February 5, 2018 Revised May 9, 2018

SUBJECT: Edison Road – Warranty and Additional Drainage Improvements

EDISON ROAD INDUSTRIAL PARK

BASIN NO. 1 TO PIPED CULVERT INLET (EXHIBIT A): The City's cost participation is \$0.00. Achen-Gardner and EPS Group will share the cost.

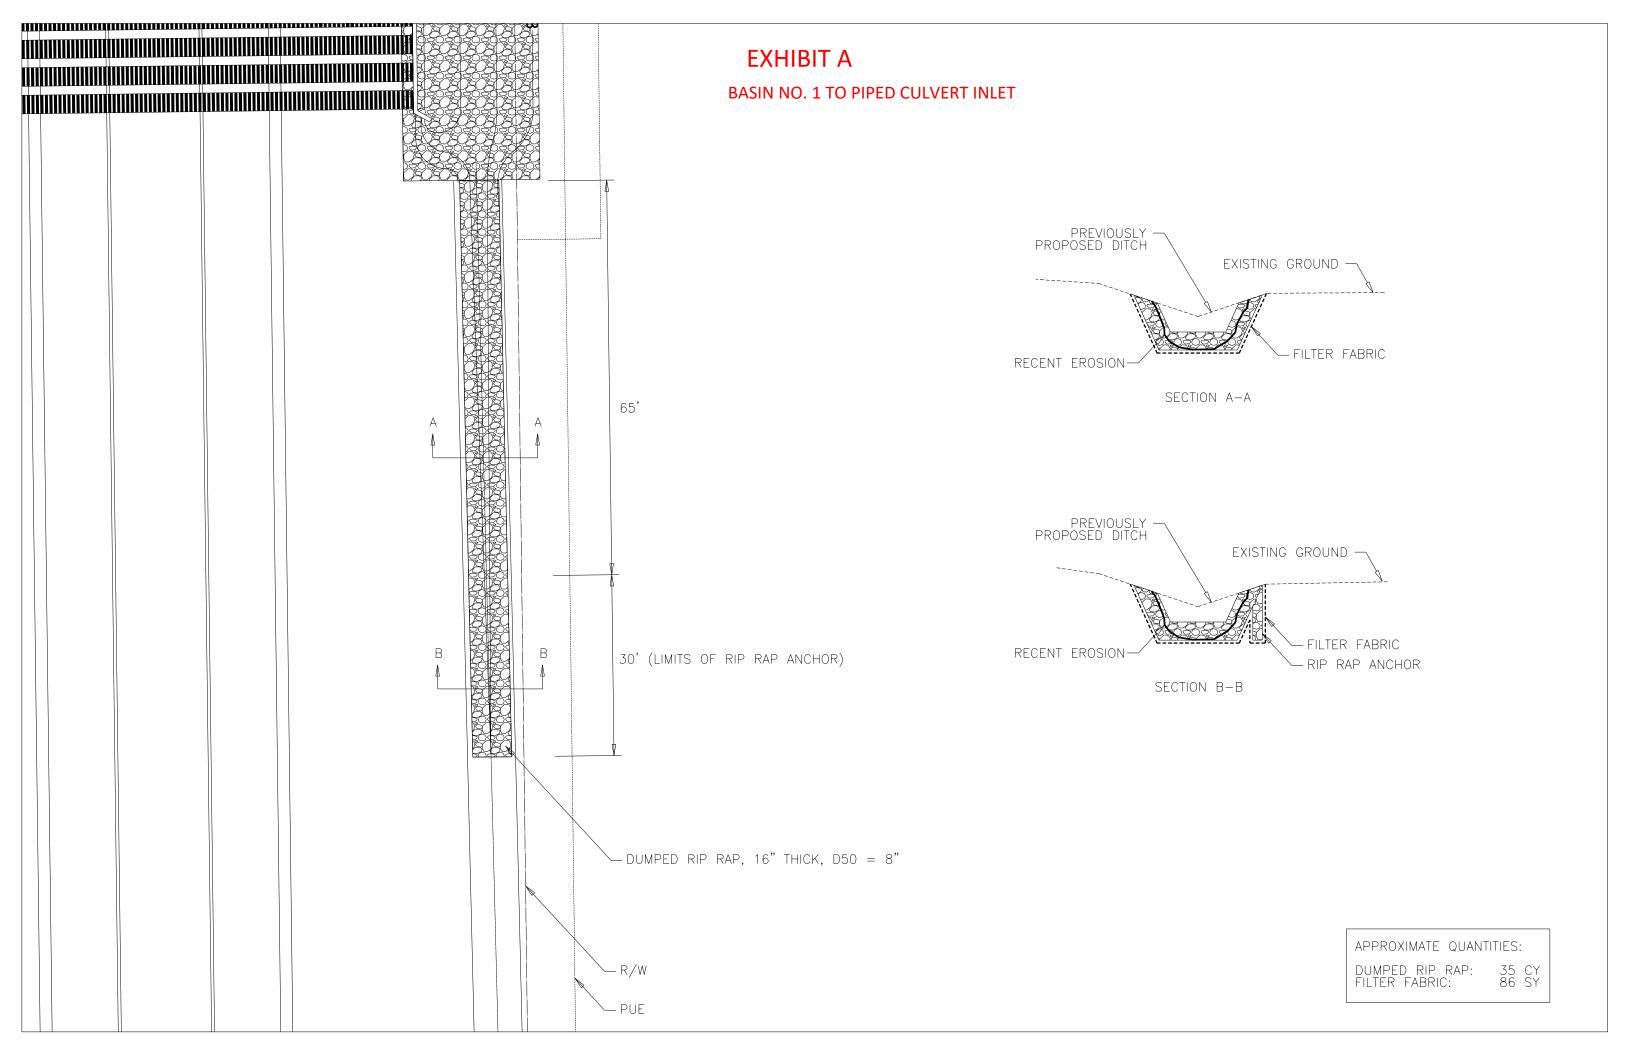
BASIN NO. 5 MDWID SPILLWAY BASIN: Includes approximately 80 feet of ditch behind walk, installing a 12' wide x 4' deep cut-off wall at the top of the basin, 28' x 12' wide rip rap spillway, 12' wide x 2' deep cut-off wall at the bottom of the slope in the basin. **The City's cost participation is \$12,029.80.**

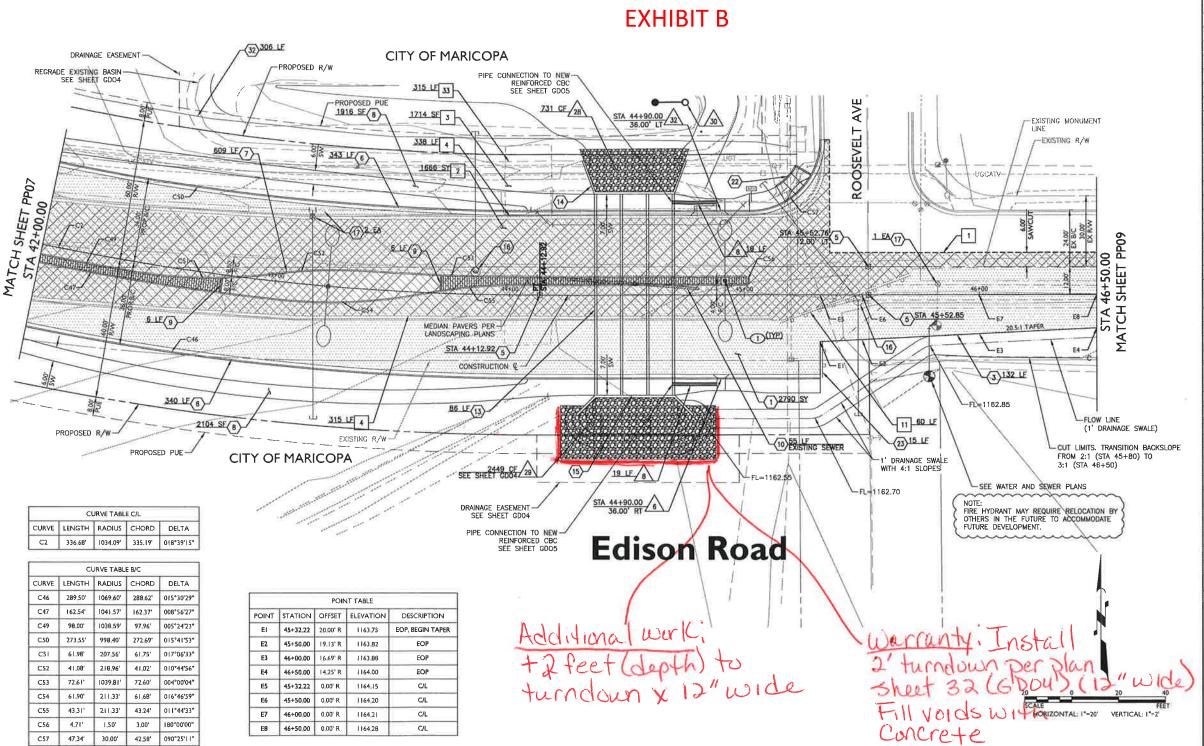
BOX CULVERT INLET (WARRANTY & ADDITIONAL TURNDOWN (EXHIBIT B): The City's cost participation shall be \$1,843.52. Achen-Gardner's subcontractor is performing the warranty work for repair of the initial 2' depth based on the contract unit pricing. The City requested additional 2' depth of rip/rap includes the additional excavation and labor, equipment, and materials to place the additional material from the 2' depth to the 4' overall depth.
